Product Change Notice/  
Product Recall Notice

<b>1. Supplier Information</b> OFS, One BrightWave Boulevard, Carrollton, GA 30117 <b>Contact Engineer:</b> Diretress Sinkfield (770)838-5302 Diretress.Sinkfield@ofsoptics.com		<b>2. Product Change/ Recall Notice No.</b>  <b>2009-0005-1 B</b>	<b>2a. Include on www.ofsoptics.com</b>  <b>Yes</b>
<b>3. Issue Date of Change/Recall</b> May 1, 2009	<b>4. System &amp; Product Description</b> Enhanced AccuFlex Plus Round Ribbon Riser Cable (up to 144 fibers)		
<b>5. New Product ID</b> RRC-nnnE-X <sub>1</sub> X <sub>2</sub> X <sub>3</sub> Where <ul style="list-style-type: none"> <li>• nnn is the number of fibers (12 - 144)</li> <li>• X<sub>1</sub> is the fiber type</li> <li>• X<sub>2</sub> is the jacket type (R=Riser, H=LSOH &amp; P = Plenum)</li> <li>• X<sub>3</sub> is the jacket color</li> </ul>		<b>6. Old Product ID</b> AT-S1S2 SF 8FLX-NNN where Where <ul style="list-style-type: none"> <li>• S1 transmission performance</li> <li>• S2 is the fiber performance</li> <li>• SF is the fiber type</li> <li>• NNN is the fiber count</li> </ul>

Figure 1: Enhanced AccuFlex® PLUS Round Ribbon Cable

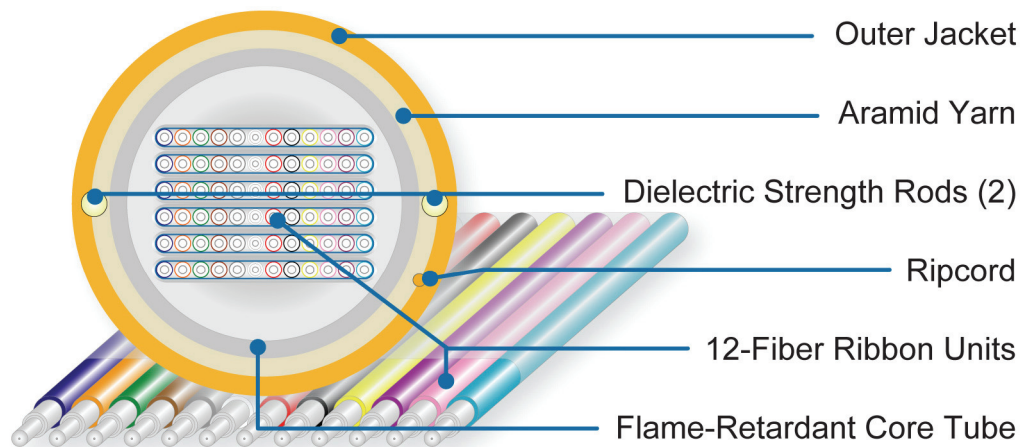
<b>7. Associated Products or Changes Affected</b> All AccuRibbon Riser cables (FLX cables) up to 144 Fibers.			
<b>8. Drawing No.</b> 087-28 & 086-06	<b>9. Product Change Classification</b> B		
<b>10. Classification Substantiation</b> Major improvement. New product.			
<b>11. Reason(s) for Change/Recall</b> Due to the limited availability of material for the FLX cables.			
<b>12. Description of Change/Recall</b> To replace all AccuRibbon Riser (FLX cables) up to 144 fibers.			
<b>13. Effect of Change/Recall</b> Change in form and fit. No change in function.			
<b>14. Material/Product Affected</b> All AccuRibbon riser ribbon (FLX) cables up to 144 fibers.			
<b>15. Documentation Affected</b> 090-024 Premises Product Coding Scheme AN-964 Quick Reference Guide for Premises Cable Codes			
<b>16. Supplier Implementation Date</b> May 1, 2009	<b>17. Modification Completion Date</b> May 31, 2009		
<b>18. Modification/Recall Location</b> N/A

- 4) Refer to Figure 1 for the cable's cross section.
